MOBILEYE FUSE RELOCATION

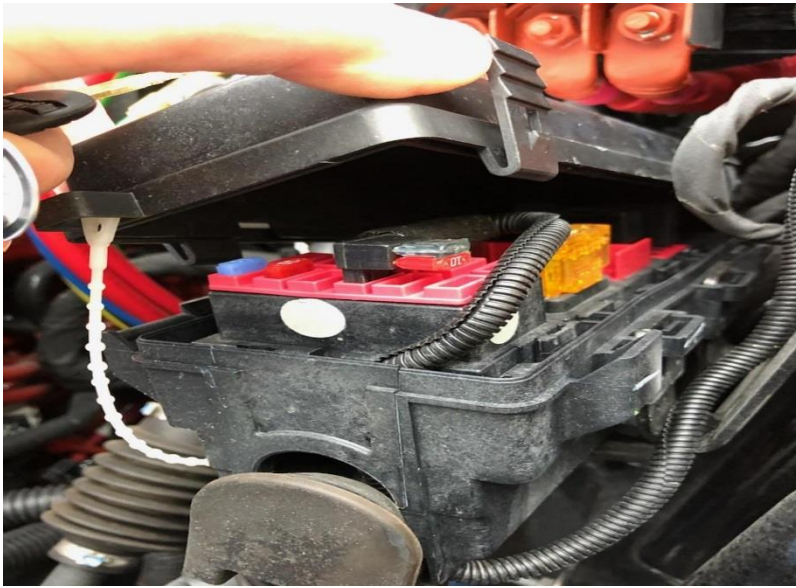
Remove the add-a-fuse assembly from the fuse block. Remove the 10 amp fuse from the add-a-fuse assembly and insert in fuse block where add-a-fuse assembly was removed. Cut the add-a-fuse assembly from the Mobileye harness and discard, then pull the harness through firewall into cab area. Route the harness over to the radio area.

Once you have access to the radio wiring harness, look for a Red and Yellow set of wires of the radio harness that are not being used. Under normal circumstances the Red would be used for the Mobileye power. However, it was discovered that the Red and Yellow wires have been swapped in some harnesses. Therefore, one should verify which of the Red and Yellow wires works off the key. The wire that has no power with key off is the wire needed to power the Mobileye.
